**Finding of No Significant Impact (FONSI)**

**Record of Decision (ROD)**

**Agency Concurrence Letters, Public Comment Letters and Responses  
to Comments, and Environmental Assessment Errata**

**For the North Texas Optimization of the Airspace and Procedures in  
the Metroplex (North Texas OAPM)**

**2014 Change of Potential Population  
Exposed to Aircraft Noise  
Proposed Action vs. No Action**

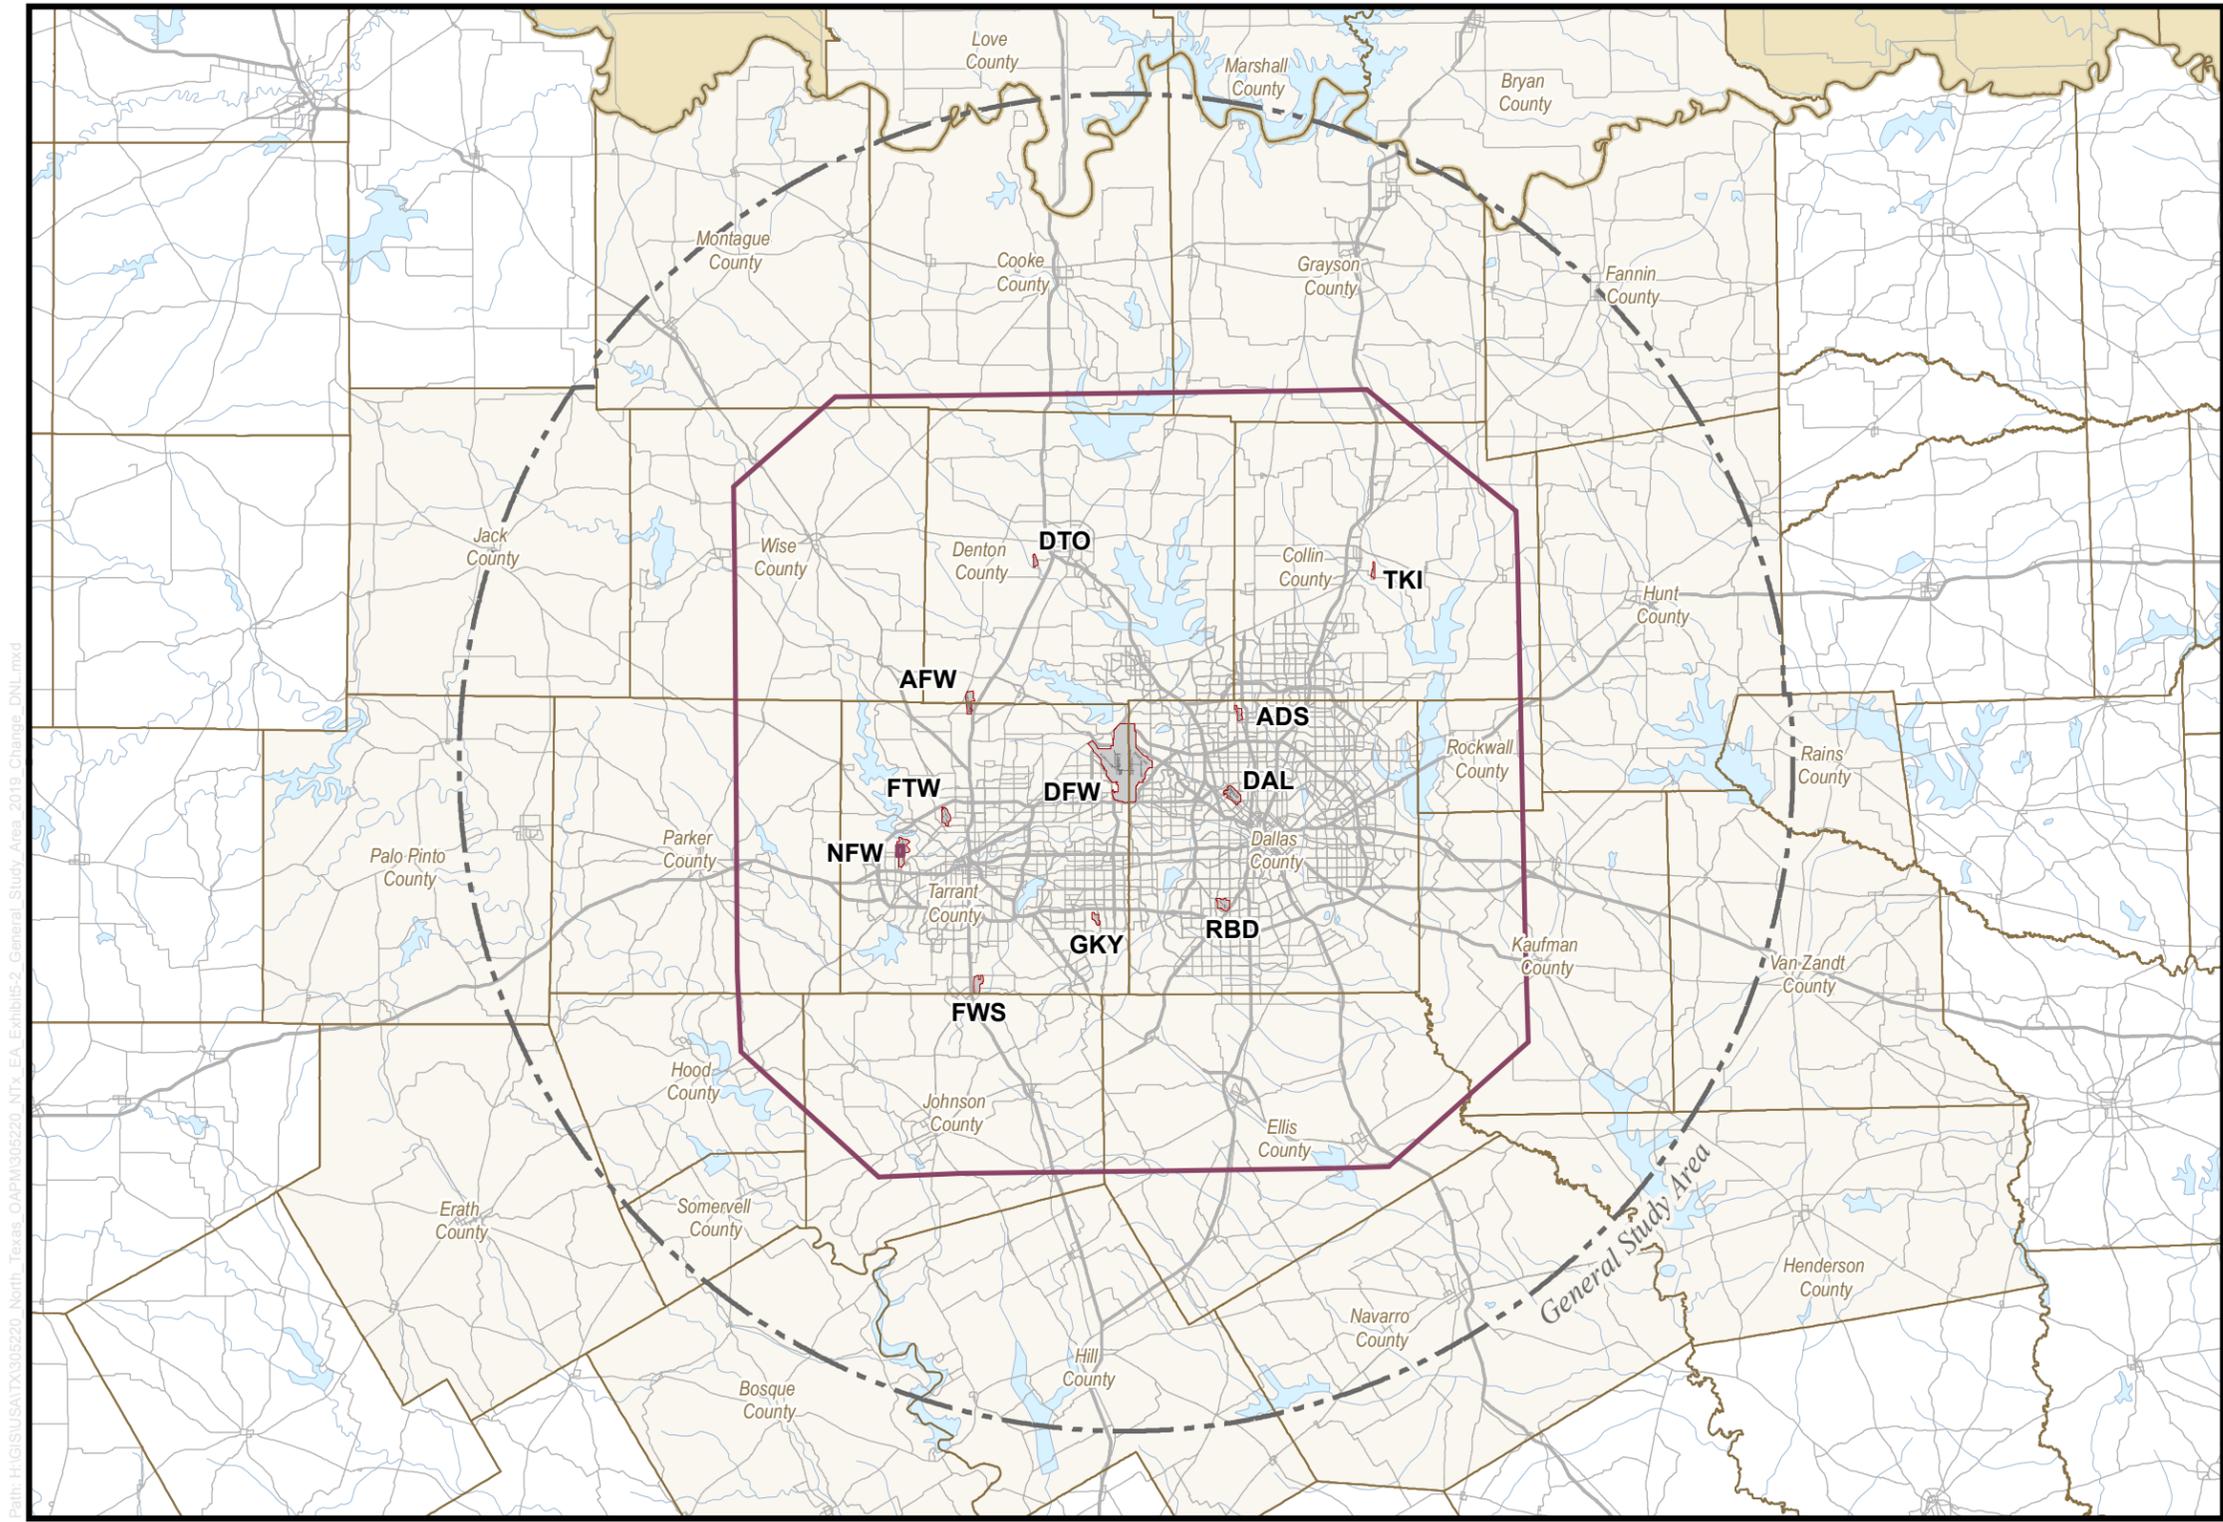
On page 5-176, Exhibit 5-1 and page 5-178, Exhibit 5-2 the following corrections will be made to correct for erroneously included information:
